“Channel” vs “Link section” effects on pair-to-pair
resistance unbalance requirements
Comment i-425, D3.0

September 2017

Yair Darshan

Background – D2.4 vs D3.0, Long Cable model.

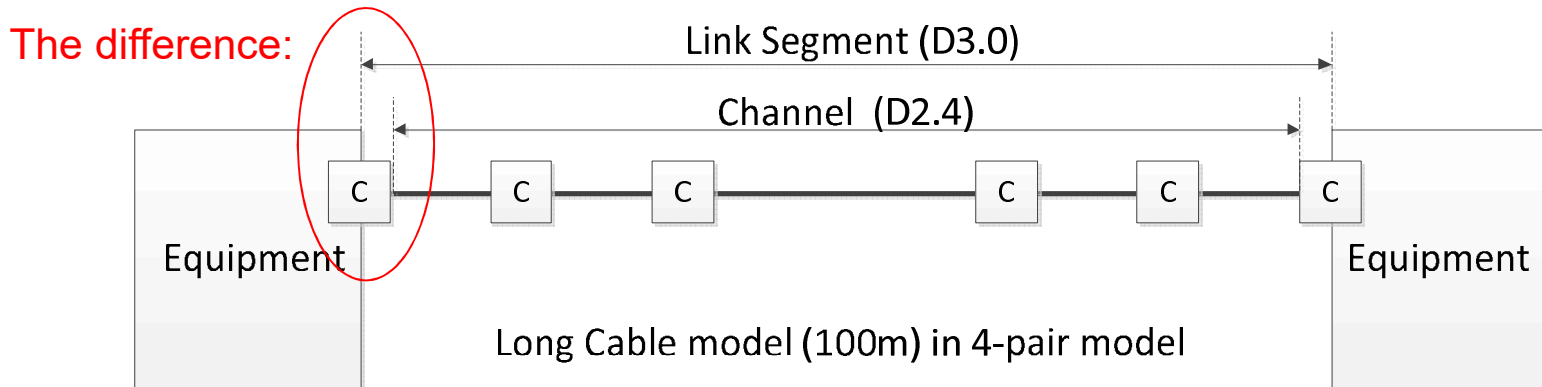
- PSE PI – equipment connector (the plug + jack) was part of the PSE PI.
- PD PI – equipment connector (the plug + jack) was part of the PD PI.
- “Channel” – consist of up to 4 connectors and 100m cordage and cable.
- Resulting with total 6 connector model from end to end.

- Link section – Includes the “Channel” connectors + the plugs going to the equipment with 100m cordage and cable. The Equipment include the Jack only.
- The question is: does it changes pair-to-pair unbalance requirements?

- In both concepts for short and long cable models, the total number of connectors and cable length from where the end-to-end pair-to-pair resistance unbalance is defined (see figure 145-22), are the same.
- ***As a result the following parameters will not be changed:***
 - Icon-2P_unb
 - Ipeak-2P_unb
 - ILIM-2P

Background – D2.4 vs D3.0, Short Cable model.

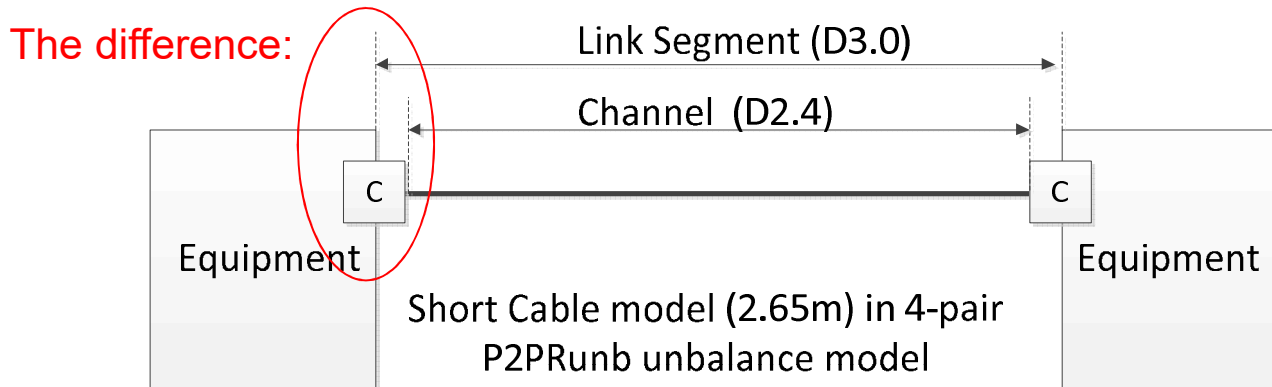
- **In D2.4**
 - PSE PI – equipment connector (the plug + jack) was part of the PSE PI.
 - PD PI – equipment connector (the plug + jack) was part of the PD PI.
 - “Channel” – consist of 0 connectors and 2.65m cordage.
 - Resulting with total 2 connector model from end to end.
- **In D3.0**
 - Link section – Include the plugs of the short “Channel” cable.
 - The PSE PI and PD PI include only the jacks.
- **The question is: does it changes pair-to-pair unbalance requirements?**
